BRIEF DESCRIPTION OF REQUEST
Administrative Amendment

SITE INFORMATION (Accuracy of the existing legal description is crucial! Attach a separate sheet if necessary.)		
Lot or Tract No.: 1-A	Block:	Unit:
Subdivision/Addition: Paseo Marketplace	MRGCD Map No.:	UPC Code: 101806332449110505
Zone Atlas Page(s): D-18-Z	Existing Zoning: MX-M	Proposed Zoning: MX-M
# of Existing Lots: 1	# of Proposed Lots: 1	Total Area of Site (acres): 4.0752

**RE: JUSTIFICATION FOR SITE PLAN AMENDMENT
PORTION OF LOT 5-A, 028, 029, AND 030 OF BLOCK 11
NORTH ALBUQUERQUE ACRES TRACT A, UNIT A**

OVERTURE SENIOR ACTIVE ADULT	DRAWN BY DY
	SITE PLAN FOR BUILDING PERMIT	DATE 1/07/2020
01/07/2020 RONALD R. BOHANNAN P.E. #7868	TERRA WEST, LLC 5571 MIDWAY PARK PLACE NE ALBUQUERQUE, NM 871109 (505) 858-3100 www.tierrawestllc.com	2017086-SPB SHEET # C1 JOB # 2017086

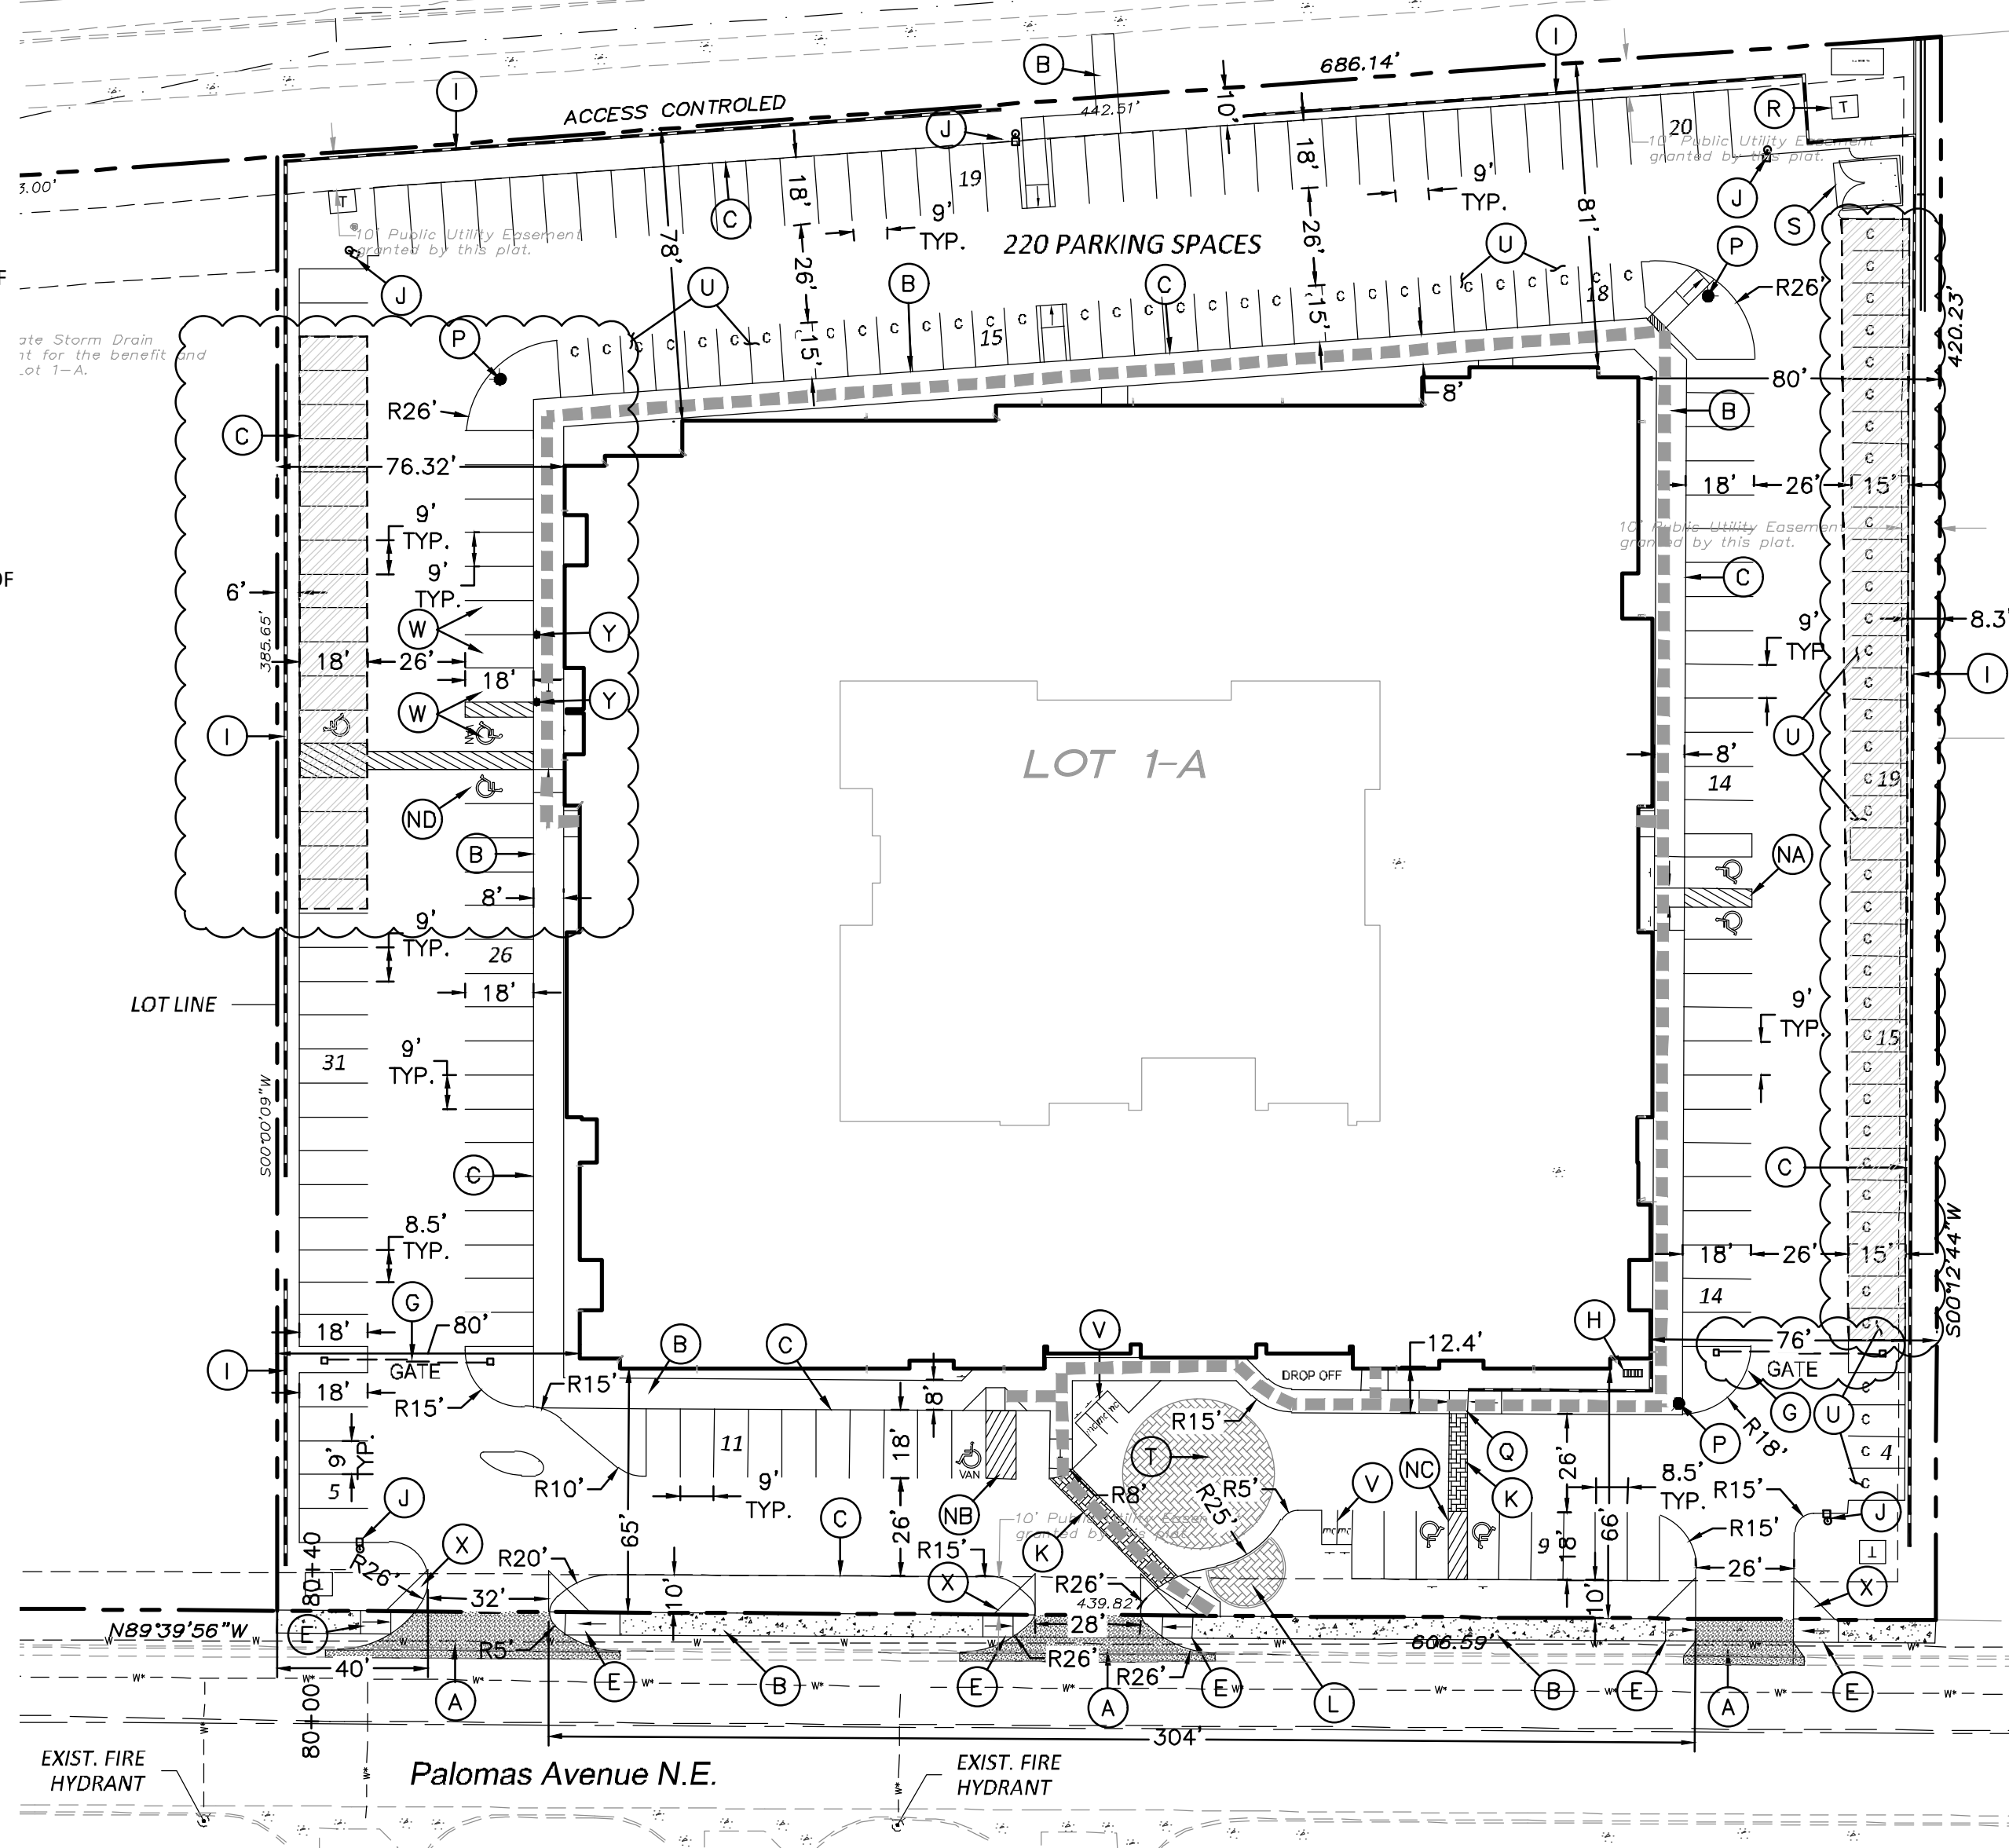
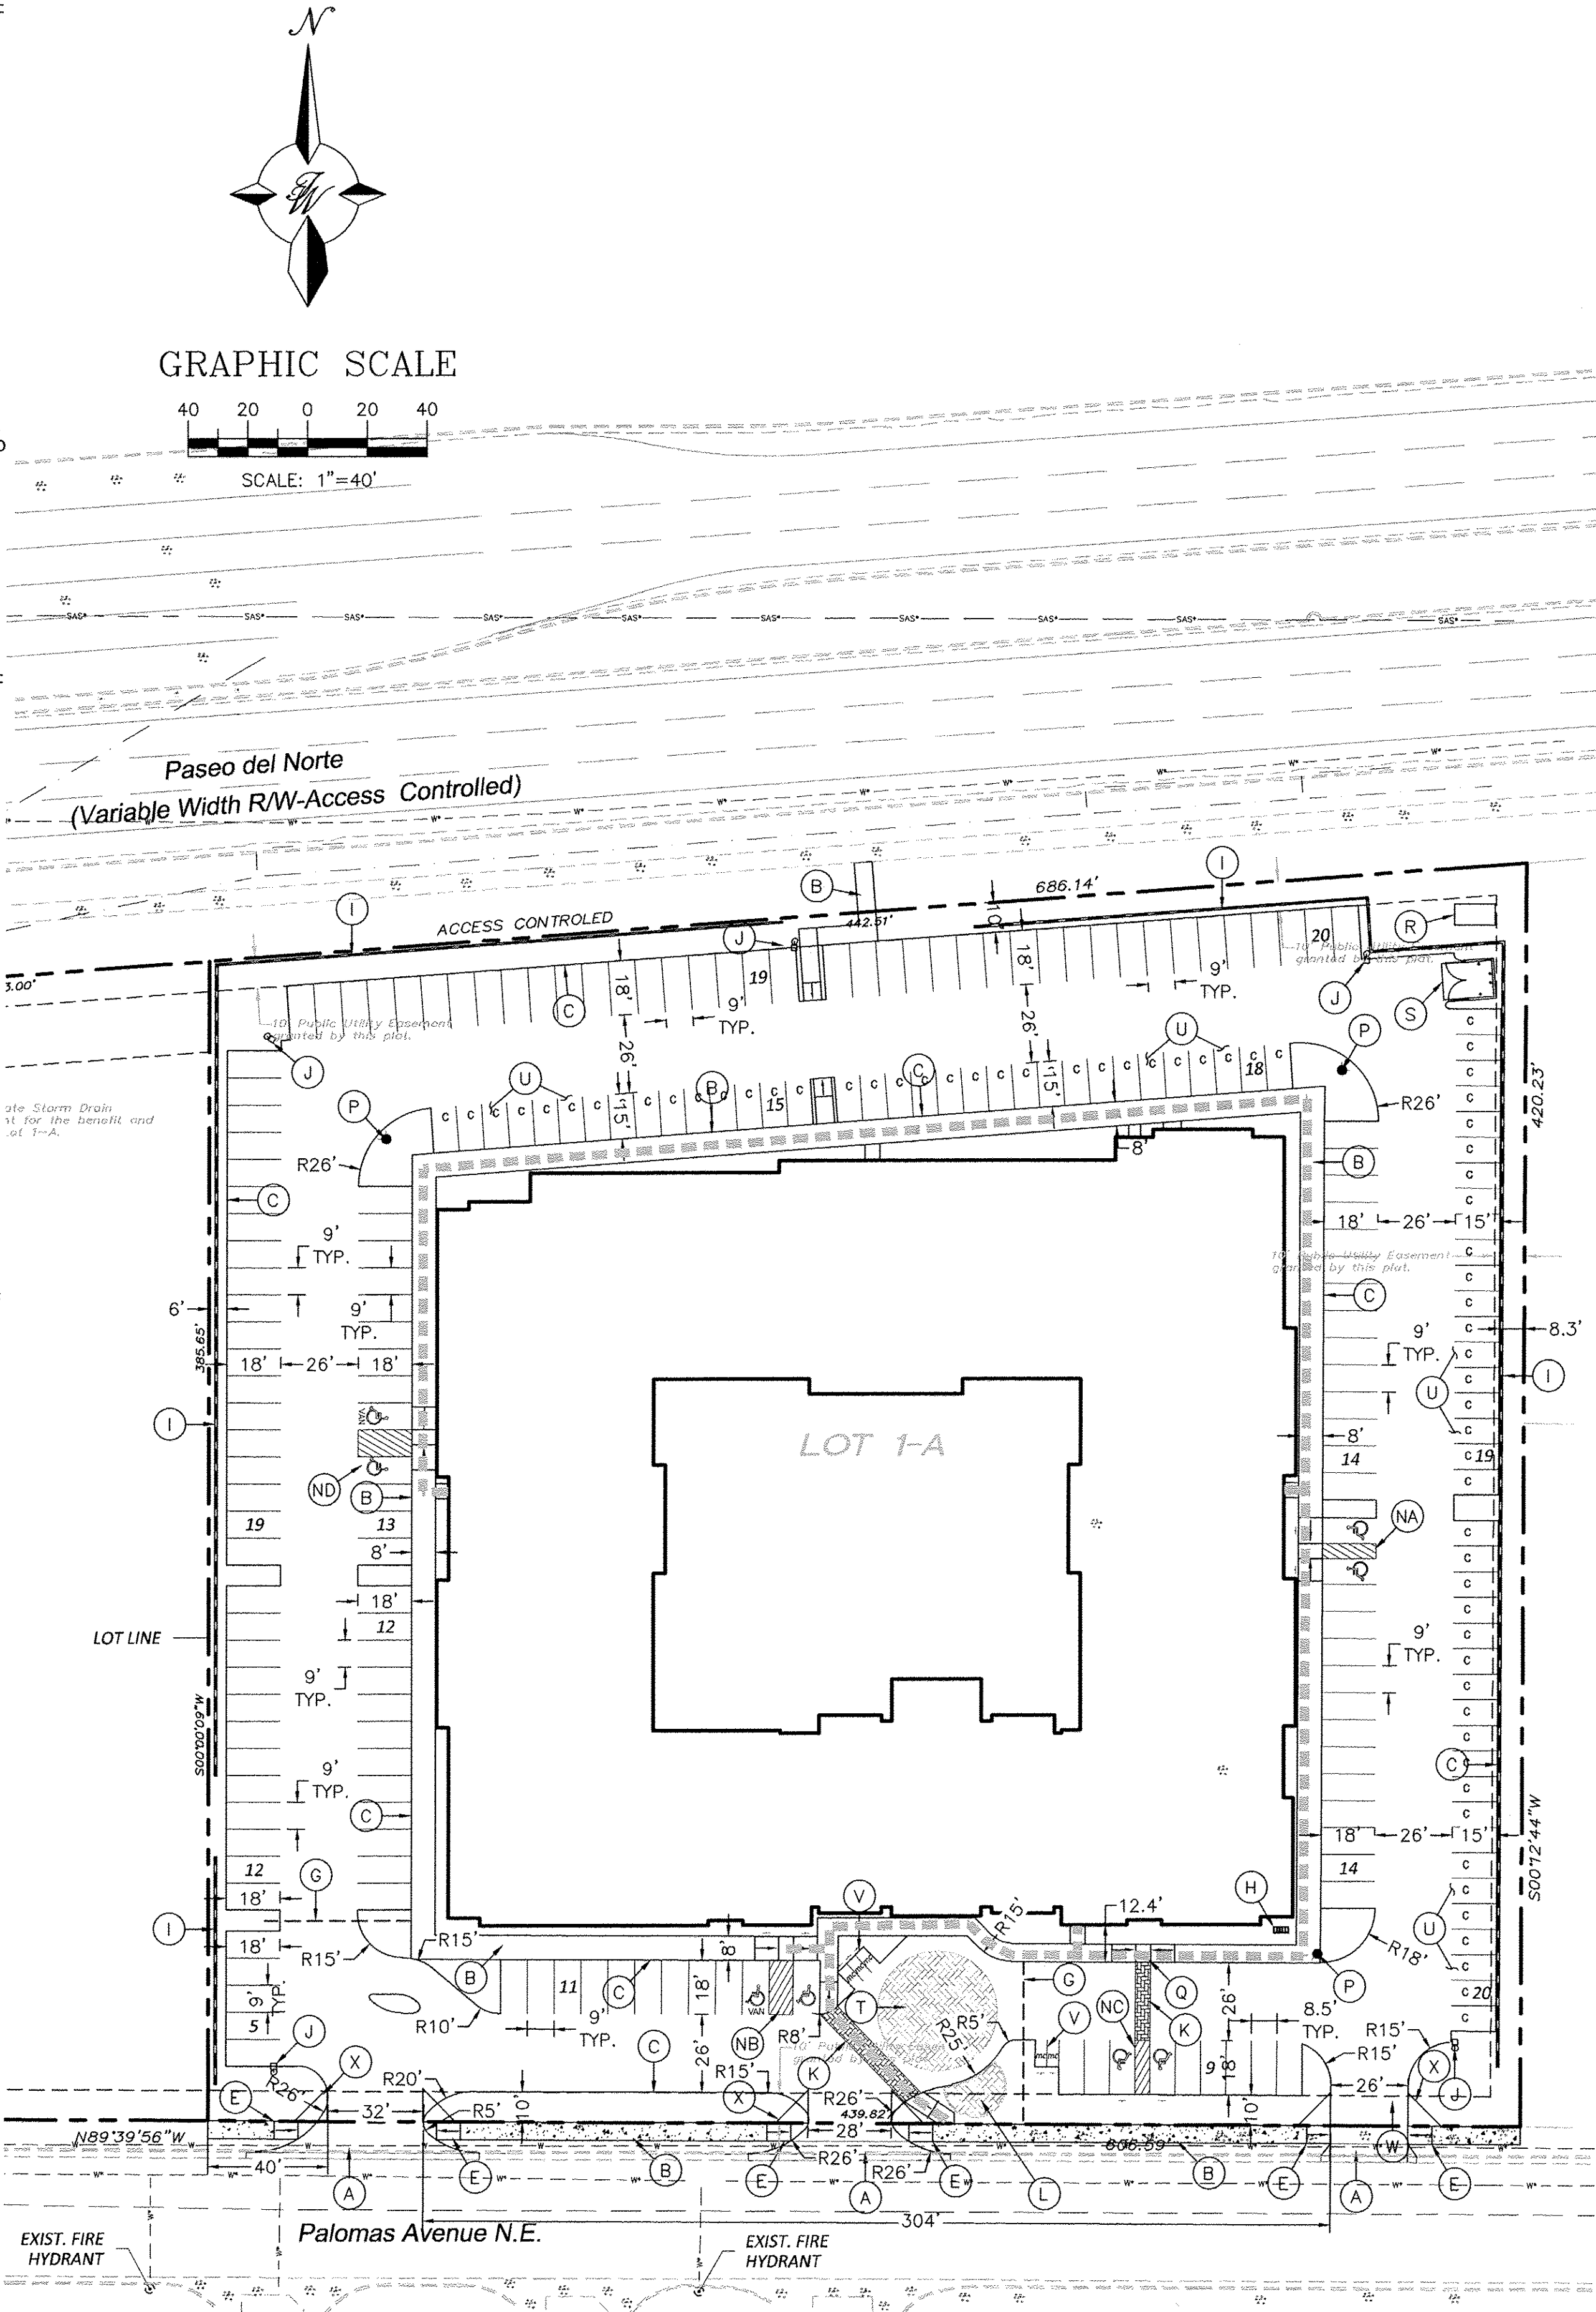
Tierra West, LLC, on behalf of our client, CRP-GREP OVERTURE ALBUQUERQUE OWNER LLC & SKARSGARD GORDON L & PATIENCE PYE, requests approval of an amended site plan for a project. The property is located on the northeast corner of San Pedro Drive and Palomas Avenue, NE and falls within the North I-25 Sector Development Plan with a zoning designation of SU-2 C-1 or SU-2 RC. Changes to the site plan include the addition of covered parking stalls and electric vehicle charging stations as well as slight modification and relocation of the vehicle exit gate located on the east side of the project.

Covered parking stalls on the east and west parking aisles have been added to the site plan at the request of the owner. These parking aisles are not visible from the street and are thus compliant with IDO Section 5-11(D)(4). The carports are also located outside of the side setbacks of the property. There is a total of 51 proposed covered parking spaces.

The addition of electrical vehicle charging stations to the site plan brings the parking lot up to compliance with IDO 5-5(C)(5)(d) which states that "When a new parking lot containing more than 200 off-street spaces is constructed, at least 2 percent of the vehicle parking spaces shall include electric vehicle charging stations with a rating of 240 volts or higher." In this case, the site has 220 parking spaces, therefore 4 parking spaces have been equipped with electric vehicle charging stations.

The vehicle exit gate that was previously located just east of the roundabout at the entrance of the facility has been relocated to the southeast corner of the building. This was done due to a combination of utility conflicts, landscaping constraints, and change in owner preference. The relocation of this gate does not affect the ADA parking compliance inside or outside the gated area. The relocation of the exit gate has removed the need for a fire only access gate on the southeast corner of the site. The new vehicle exit gate will have a Knox box for Fire Department Access. An updated Fire One plan is being submitted at this time to reflect these changes in the access regime.

PARKING FACILITIES:
CAR CHARGING STATIONS REQUIRED: 4 SPACES
CAR CHARGING STATIONS PROVIDED: 4 SPACES
PARKING REQUIRED: 220 SPACES (PER ZHE VARIANCE) (17ZHE-80268)
TOTAL PROVIDED: 220 SPACES (140 STANDARD; 72 COMPACT; 8 HC)
TOTAL COVERED PARKING: 51 SPACES
HC PARKING REQUIRED: 8 SPACES (2 VAN ACCESSIBLE)
HC PARKING PROVIDED: 8 SPACES (2 VAN ACCESSIBLE)

- (U) COMPACT PARKING SPACES (SEE DETAIL SHEET C4)
- (V) MOTORCYCLE PARKING SPACES (SEE DETAIL SHEET C4)
- (W) PARKING W/ELECTRIC VEHICLE CHARGING STATIONS

- (X) SIGHT TRIANGLE. SEE GENERAL NOTE 7 THIS SHEET.
- (Y) CAR CHARGING STATION
